London Biggin Hill Airport

Consultation Response Document ACP-2019-086

Date: 1st May 2024

Reference: ACP-2019-086

Route Option 9 – The Missed Approach Procedure

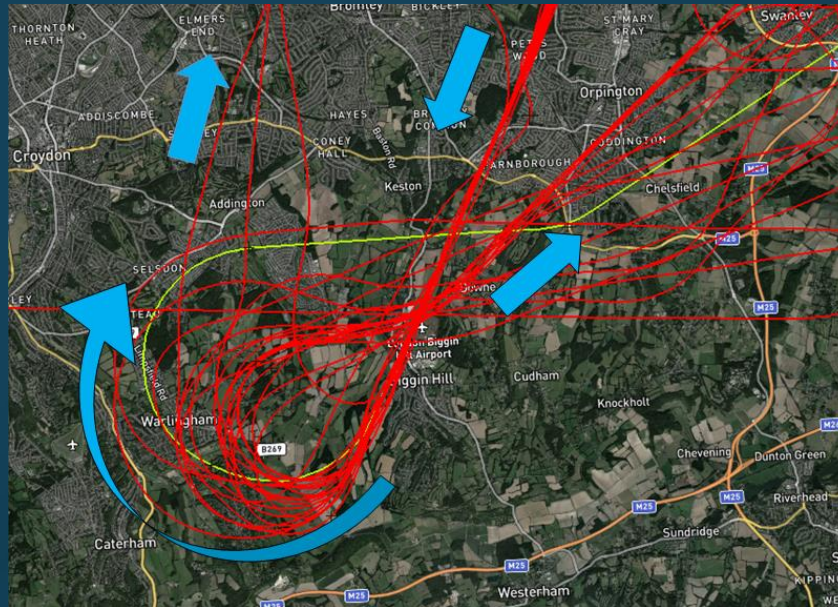
The MAP procedure could be kept tighter, to be closer to the Noise Preferential Route from R21, that was devised to keep aircraft away from residential areas at the North of the airport and that is too often disregarded.	Potential changes to the MAP are being actively investigated and considered by LBHA and the respondent's comments will be considered in any changes made to the MAP.

Serial	Response ID	Response Summary	LBHA Response/Action	Response Theme	Any Relevant Considerations/Feedback
		<p>Of primary concern with the proposals is the route proposed for the Missed Approach Procedure. The proposed route goes through the Warlingham/Woldingham Noise Sensitive Area (NSA) and then travels east to the north of the airport, before travelling north-east through a substantial section of the NSA around Green Street Green.</p> <p>This route should be altered to reduce disruption to residents by avoiding built up areas. Primarily, as aircrafts travel back east past the north of the airport, it is paramount that built up areas are avoided.</p> <p>There seem to be a number of options for the exact line to achieve this. One option may be travelling directly over the airport. Regardless of the route selected, this should avoid any NSA by a reasonable margin and not turn north until clear of the Orpington and Farnborough NSA, most probably by travelling over the Pratts Bottom Nature Reserve.</p>	<p>Potential changes to the MAP are being actively investigated and considered by LBHA and the respondent's comments will be considered in any changes made to the MAP, including routing aircraft through the airport overhead when executing the procedure.</p>

To avoid any possible interaction with aircraft conducting an approach to Runway 21, the Missed Approach Procedure has been adjusted to track aircraft back through the airfield overhead before returning to the Hold. Once through the airfield overhead, aircraft will track south-east before turning north to join the Hold.

The solution proposed responds to many consultees concerns about the potential impact of the procedure by routing aircraft over the middle of the runway and keeping aircraft away from residential areas.
